**COMMISSION OF ARCHITECTURAL REVIEW  
STAFF REPORT  
November 28, 2017 Meeting**

8. **COA-026404-2017** (K. Johnston)

**800 North 22<sup>nd</sup> Street  
Union Hill Old and Historic District**

**Amend previously approved rear and south elevations for the rehabilitation of a home and replace the front porch roof.**

800 North 22<sup>nd</sup> Street Building Permit Elevations

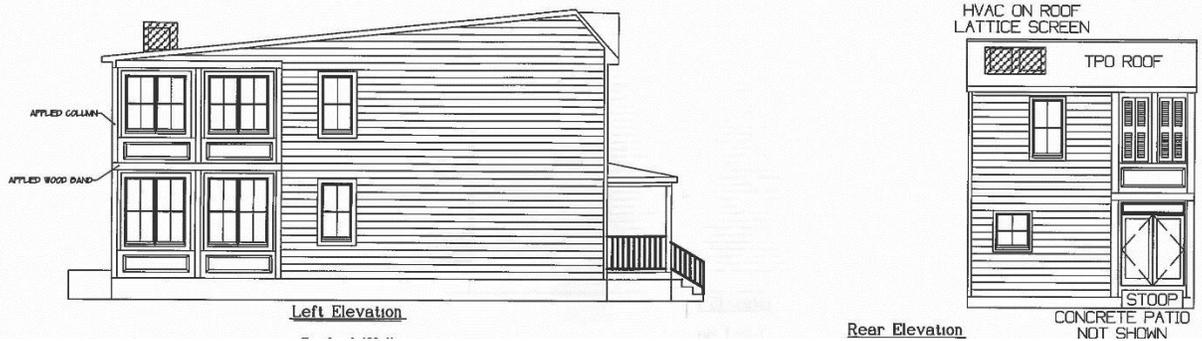
The alterations to the structure were not completed per the approved building elevations. Specifically, the details of the porch enclosure were not included on the side and rear elevations. After determining the building permit plans were not consistent with the work completed at the property, staff worked with the applicant to review elevations which maintained the location and size of the existing windows and doors and included porch details and shutters to be compliant with the Commission's approval. Unfortunately, the proportions and alignment of these details did not effectively convey the appearance of a porch enclosure. With this application, the applicant is requesting approval for the structure as it has currently been rehabilitated. In addition to the changes to the

**Staff recommends approval of the project with conditions.** Per the Sanborn maps, the structure was developed with a two story side porch in the location of the first story porch. In June 2016, the Commission reviewed the alterations to the side and rear of the structure under the standards for a porch enclosure based on the original appearance of the structure. These guidelines encourage the use of glazing and details that reflect porch elements (pg. 71, #13). As the second story was enclosed prior to the establishment of the Old and Historic District, staff supports the current design as it is the same design as the previous porch enclosure with modifications to one existing window opening on the Cedar Street elevation. The Commission's *Guidelines* note that the architectural appearance of original windows should be used as a model for new windows (pg. 69, #10). Staff supports the modifications to the opening to allow for longer paired windows as it was the modification of an existing non-original window opening to a length consistent with the historic windows on the structure. Staff recommends the trim detail on the rear elevation of the 2<sup>nd</sup> story be removed as it no longer relates to porch details. As the first story was recently an open porch, staff recommends an attempt be made to meet the Commission's Guidelines for porch enclosures with the inclusion of an engaged column between the pairs of windows on the Cedar Street elevation.

The Guidelines note that membrane roofs are an acceptable substitute for flat-lock seamed metal roofs (pg. 49, #5). Staff recommends approval of the proposed membrane front porch roof with the condition that the existing roof shape be maintained.
